Construction of a Town Hall at Chittagong

SUBJECT Construction of a town hall at Chikballapur

Plans for constructing a Town Hall at Chittallapur

Estimate for the probable cost of Constructing a Town Hall at Chikballapur as per plan attached — Duplicate

Ground Plan

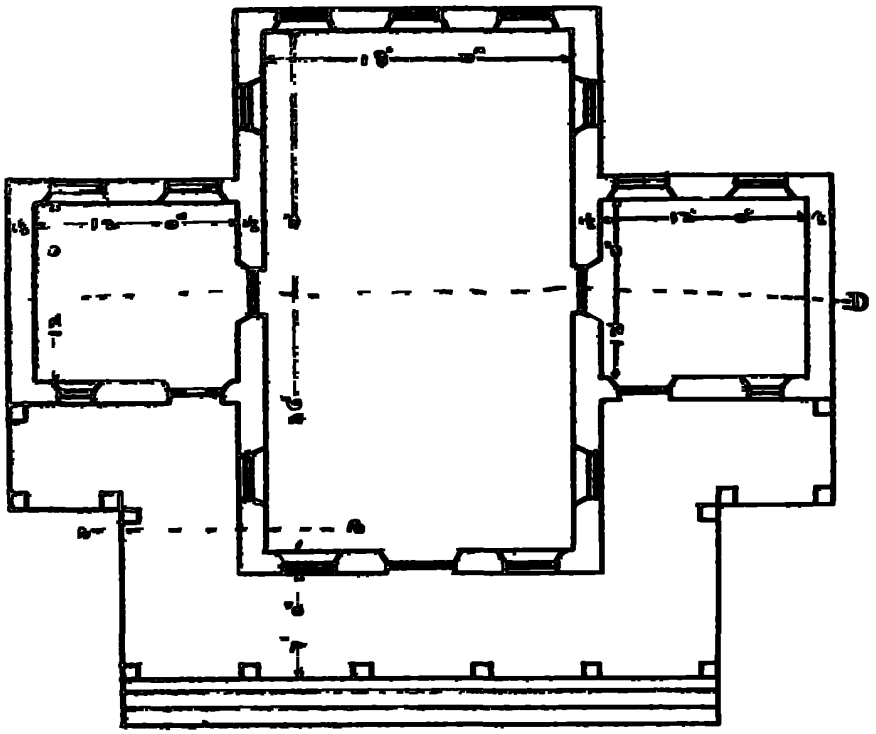
Recorded with the observation that the dimensions of the Town Hall should be 18'x 36 and that a revised Plan and Estimate in accordance with these dimensions may be submitted to Government for their sanction

Section on AB

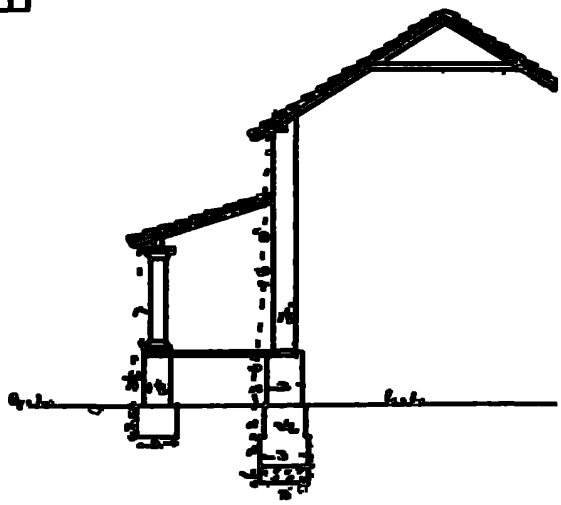
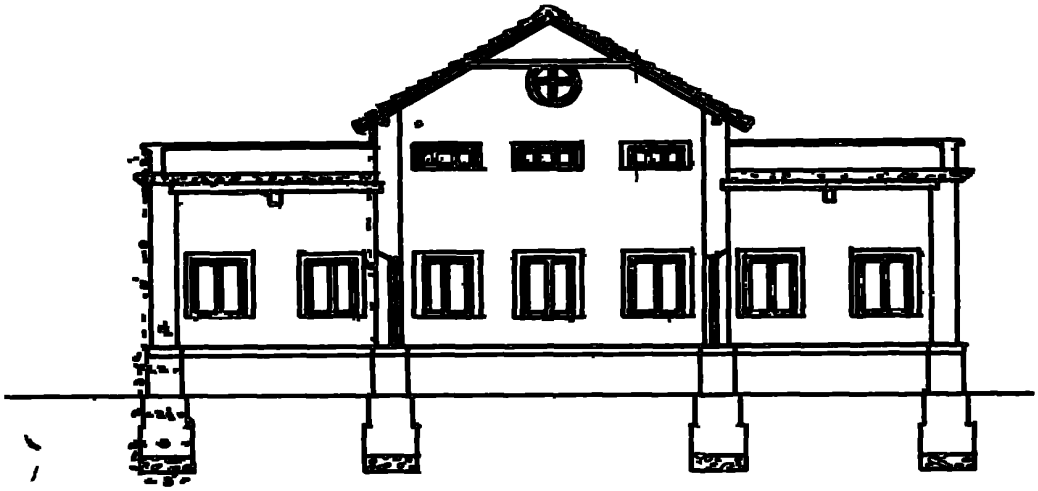
It is seen that only a part of the
cross-section of the building is drawn
It may not be desirable to submit to
Government the drawing, as it is now
Therefore the President is requested to
cause the cross-section drawn in full,
So that the whole building may be
at one look and to submit the revised
drawing early

Has the honor to forward
herewith the Cross-Section of the
Lean-Hall building as required in
the above
